4L60 (700-R4)-Auxiliary Valve Body Data

Auxiliary Valve Body:

Auxiliary Valve Body

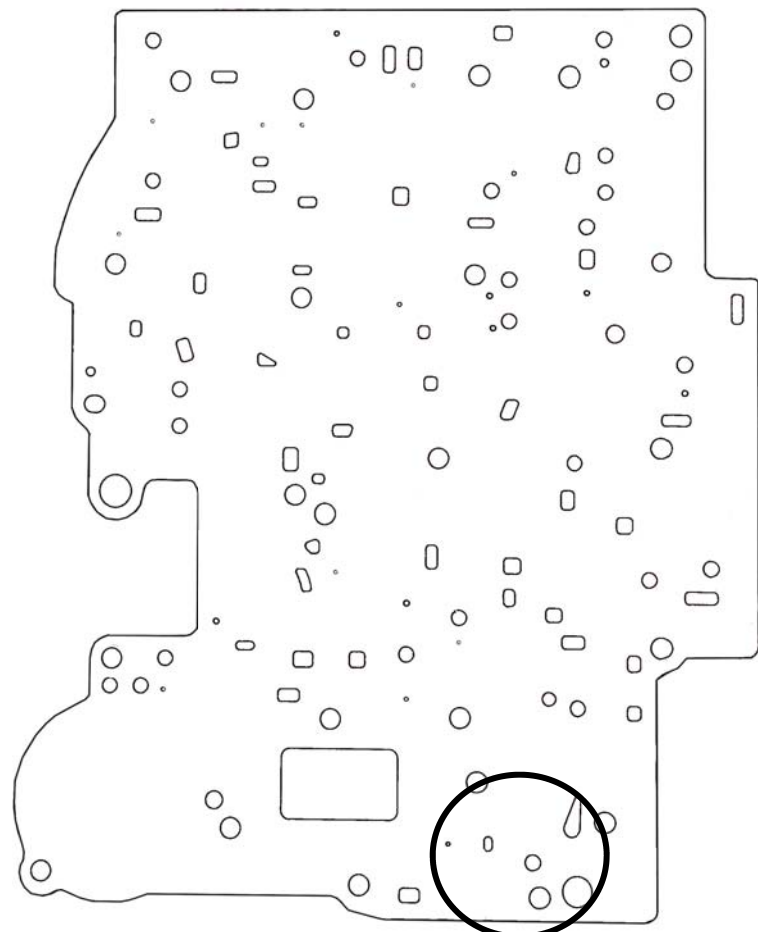
The auxiliary valve body was introduced near the beginning of production for all 1987 and later models. The primary purpose was to provide smoother forward and manual low pull-in engagements. In addition to the auxiliary valve body itself, the case, spacer plate, pump, and input drum were changed as well.

An additional hole was added to the pump cover (stator) to accommodate the new forward clutch feed tube from the auxiliary valve body.

Spacer Plate

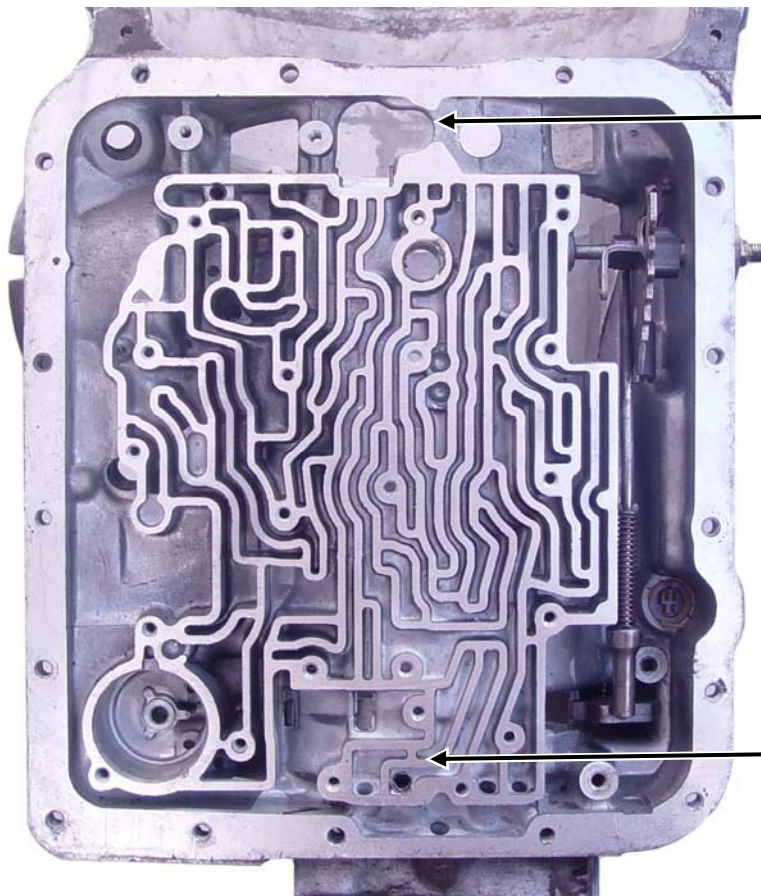
Several new holes were added to the plate for the addition of the auxiliary valve body.

Filter hole opening larger to allow tube to install into pump cover.

Dam added here

Forward clutch feed hole was eliminated from the case. Forward clutch feed is fed through the new tube.
